U.S. Department
of Transportation
**Federal Highway
Administration**

Maintenance of Pavement Underdrain System

MAINTENANCE OF PAVEMENT UNDERDRAIN SYSTEM

ROCK BLOCKING OUTLET

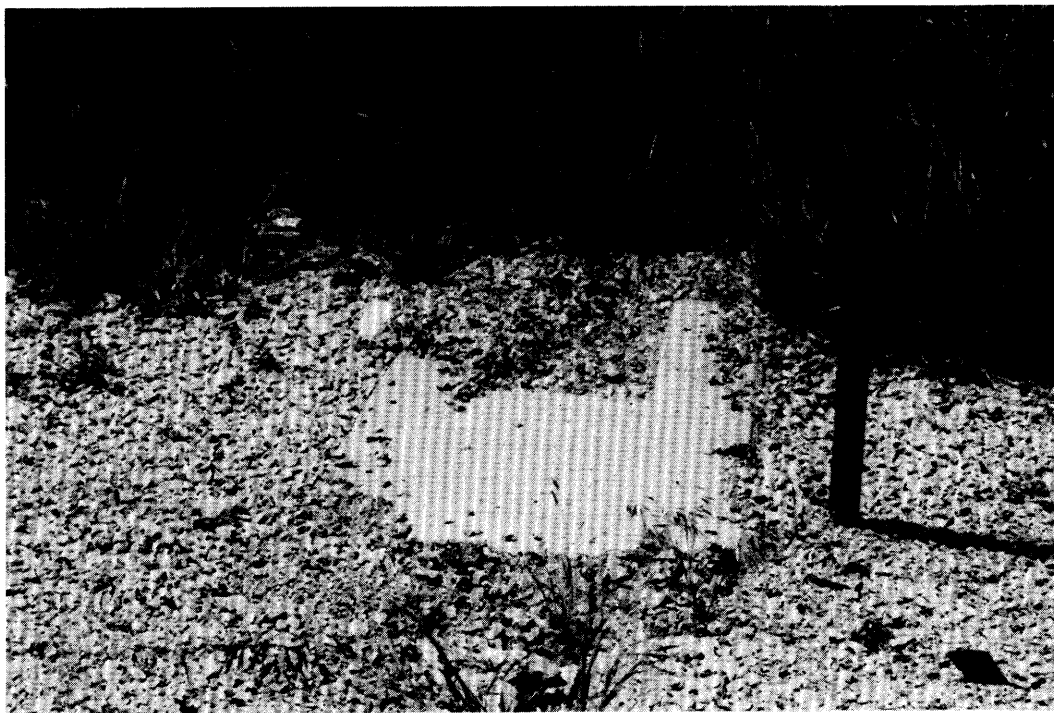
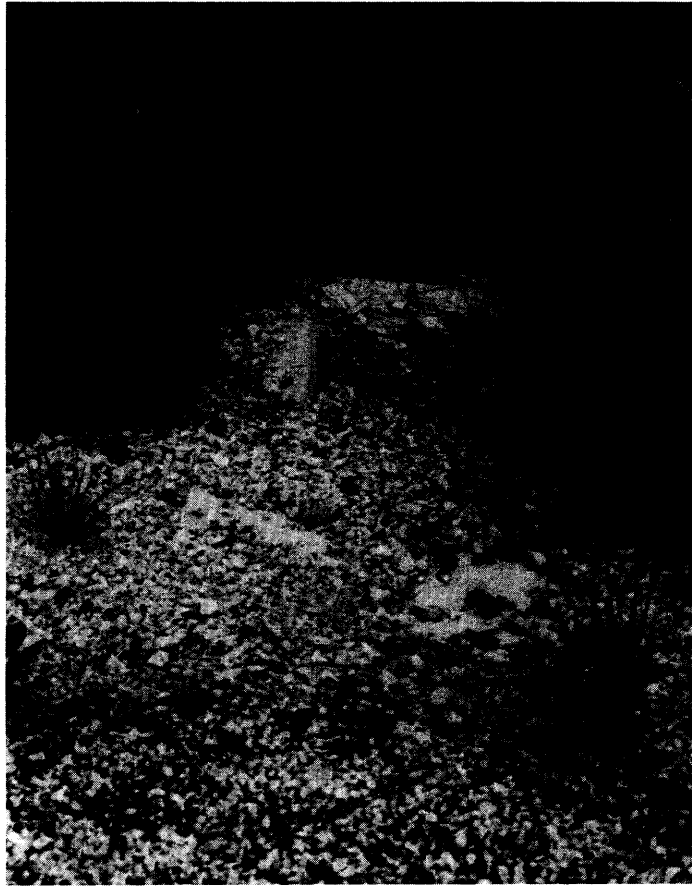
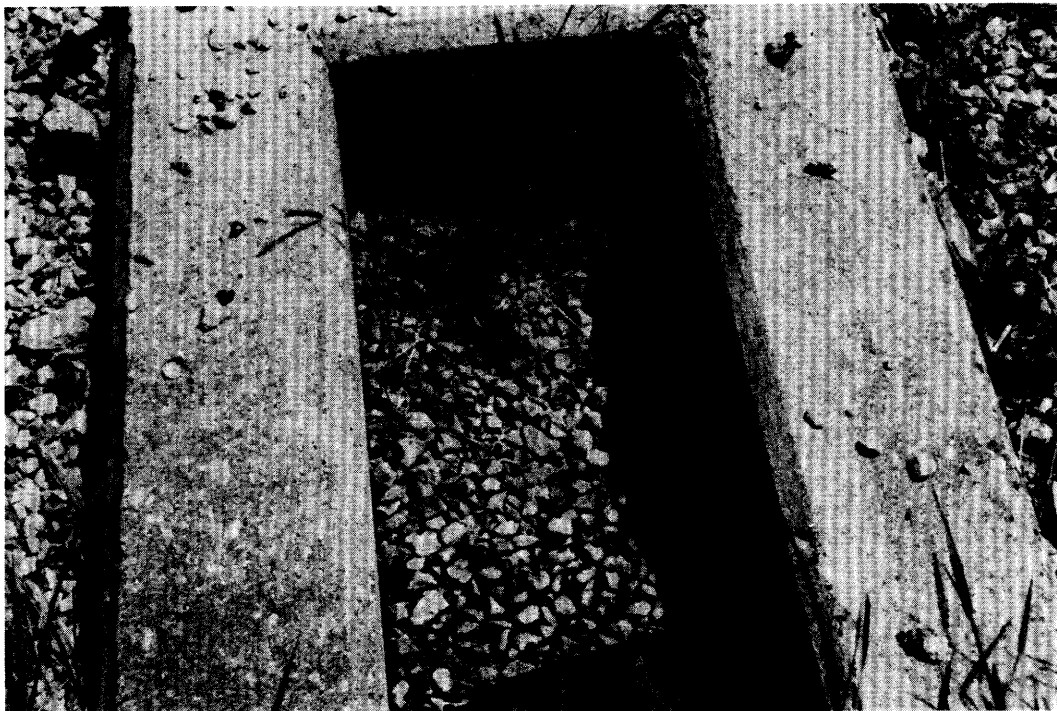
- **Rock Blocking Outlet, Attachment A**
Crushed stone from the shoulders was found to be the most consistent and probable cause of the blockage. Occasional maintenance checks should have greatly eliminated this problem.

- Dense graded aggregate and/or chip seal aggregate from the shoulder had filled numerous troughs resulting in the pipes becoming totally clogged.

It is recommended that a list of locations of headwall troughs prone to blockage be kept so frequent checks are assured.

SILTED HEADWALL TROUGHS

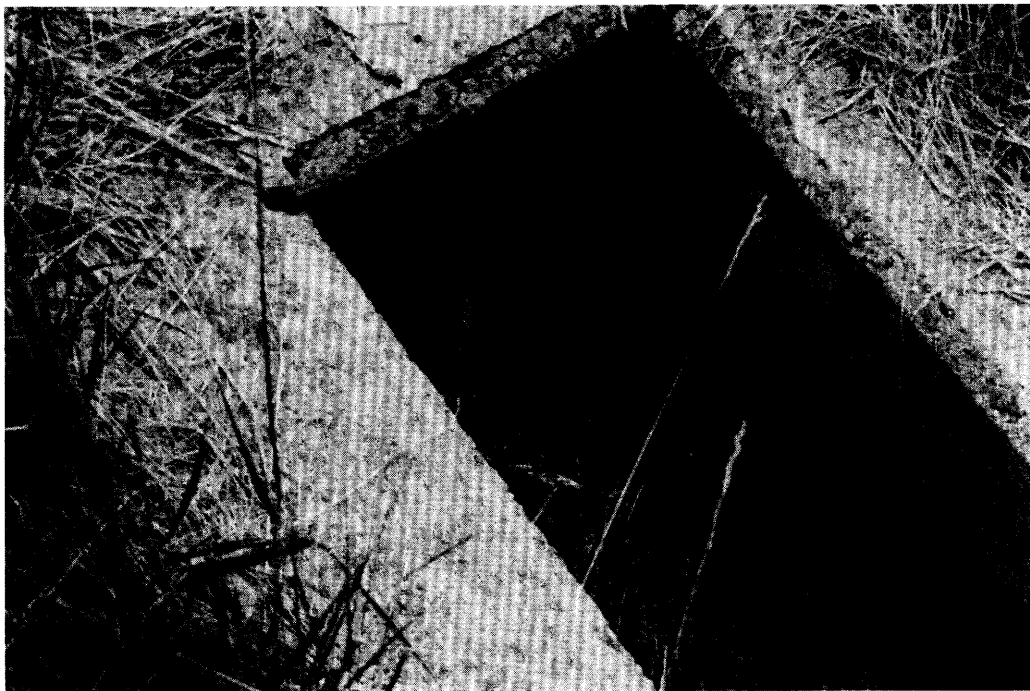
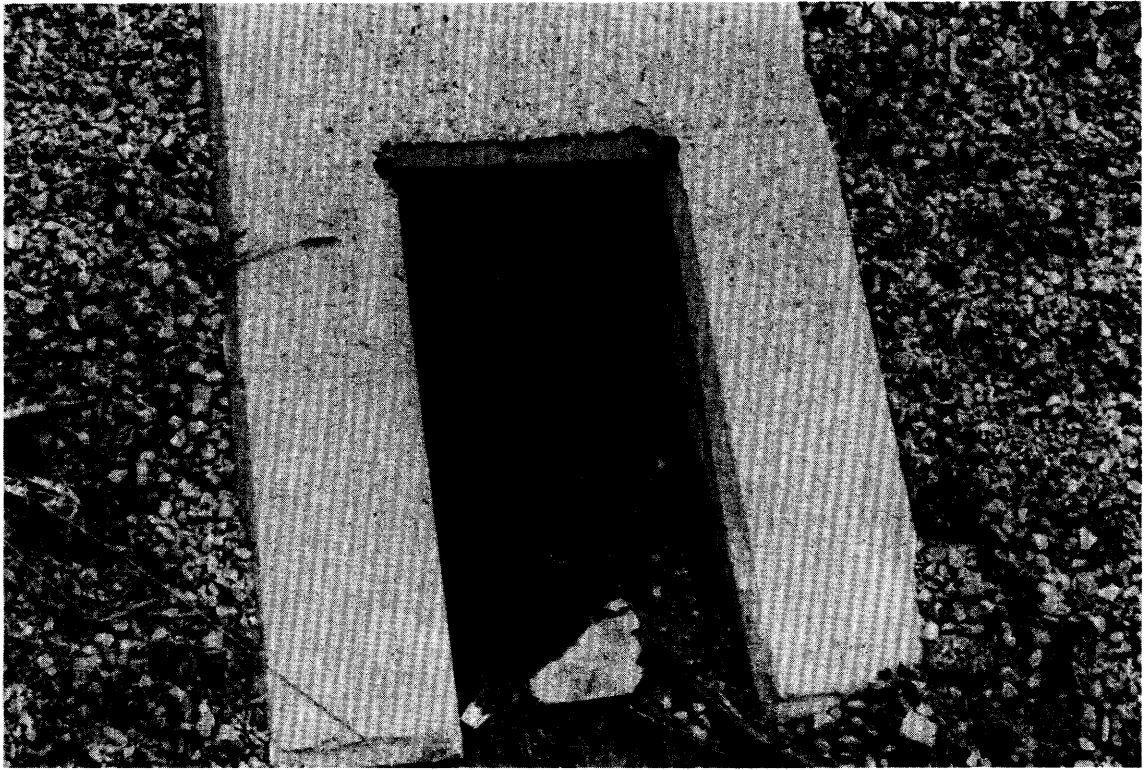
- **Silted Headwall Troughs, Attachment B**
Partially blocked headwall troughs allowed silt to build-up in the troughs preventing silt from being washed through the trough. Some large cut sections have ditches filled with material possibly completely covering the headwalls.

- There were numerous headwall troughs completely full and many more partially filled from sediment.

It is recommended that the design for underdrain pipe headwalls be revised to have the pipe outlet above the headwall apron to allow for some sediment, if routine maintenance is expected to be haphazard and infrequent.

VEGETATION BLOCKING OUTLET

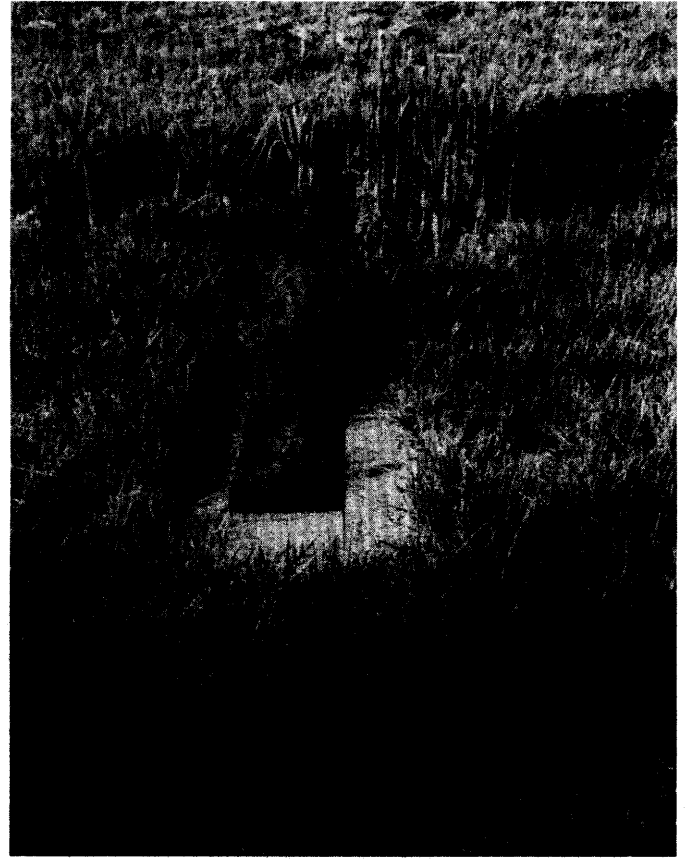
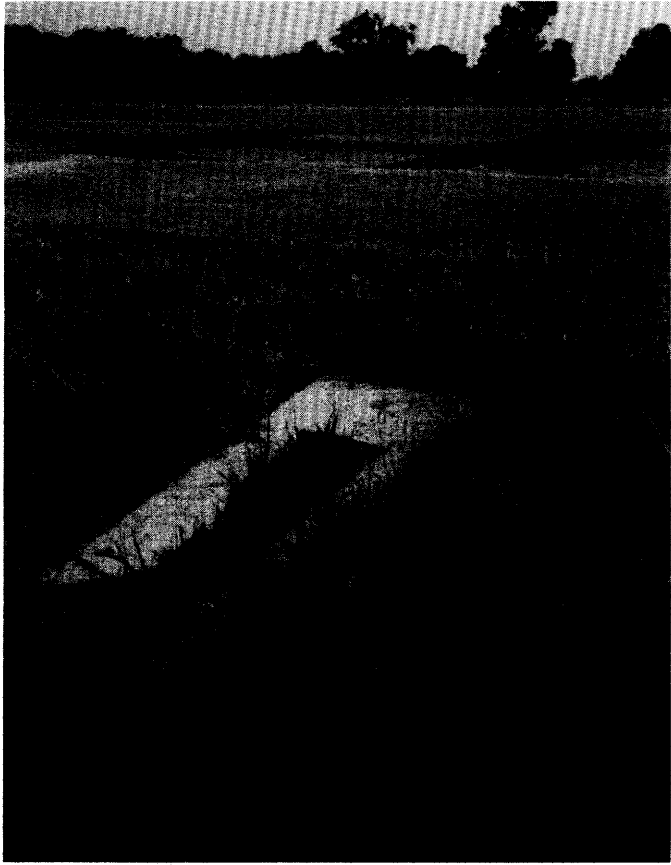
- **Vegetation Blocking Outlet, Attachment C**
Vegetation retains the silt causing gradual build-up to where many outlets were largely blocked. Trimmings from mowing operations were found to be the cause of some blockages.

DITCH HIGHER THAN OUTLET

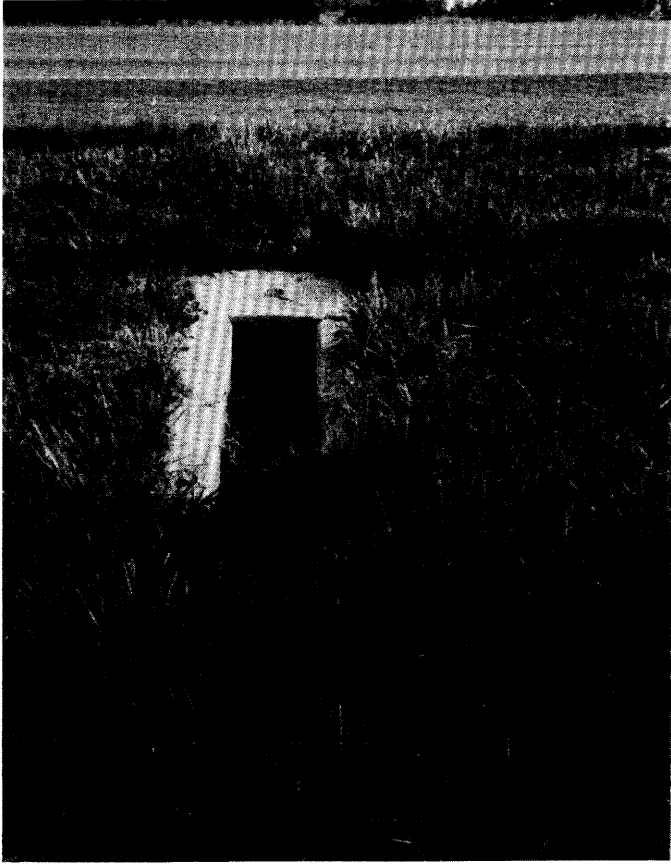
- **Ditch Higher Than Outlet, Attachment D**
Headwalls were found to be constructed such that frequent maintenance would be required to keep the outlets clear. Water in the ditches would block many of the outlets.

- There was a recently completed resurfacing project, with small cut slopes, that had numerous headwall outlets located about ditch level. There were a couple of old projects that the outlets could not be found in long cut sections for which the ditches were filled with material. It is believed that some outlets were completely covered with this material.

It is recommended that a minimum height be established for the outlets above the ditch flowline, that would reasonably assure that water would not back up into the pavement.

CLOGGED OUTLET PIPE

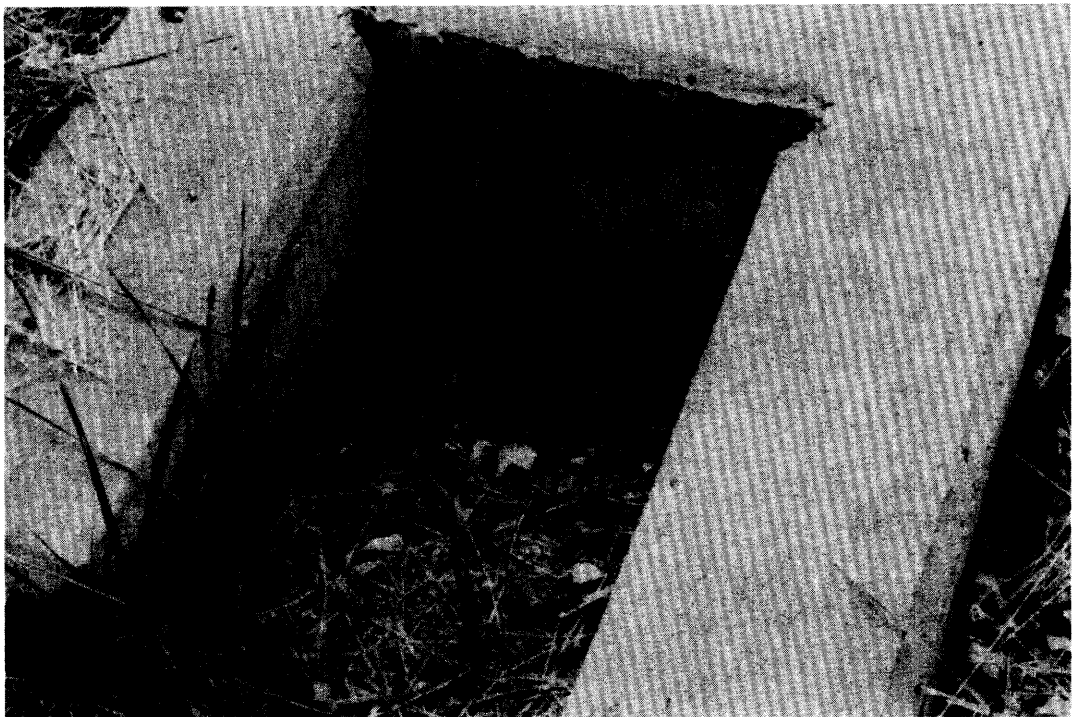
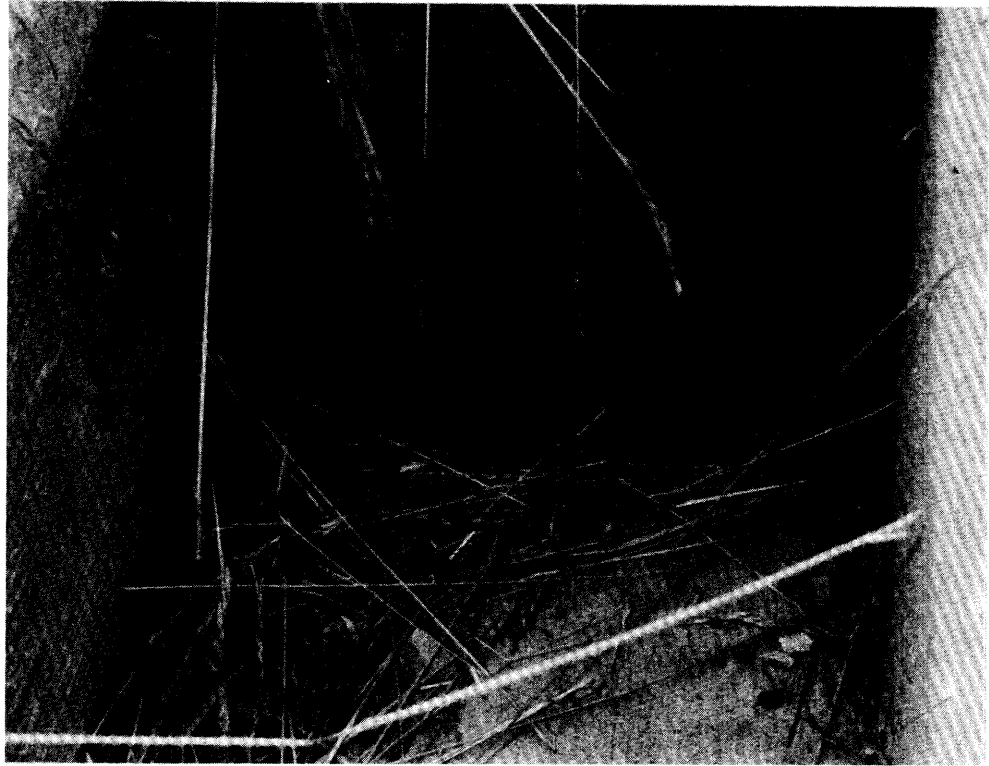
- **Clogged Outlet Pipe, Attachment E**
Clogged outlet pipes were found at many locations. Some were recent installations. Some had the old heavy type screens. Some pipes were clogged even though the troughs were clear, perhaps cleared after the blockage.

- There were several old-heavy type screens that may have caused the pipes to become silted back of the screens.

It is recommended that consideration be given to removing these screens in areas that silt has built up.
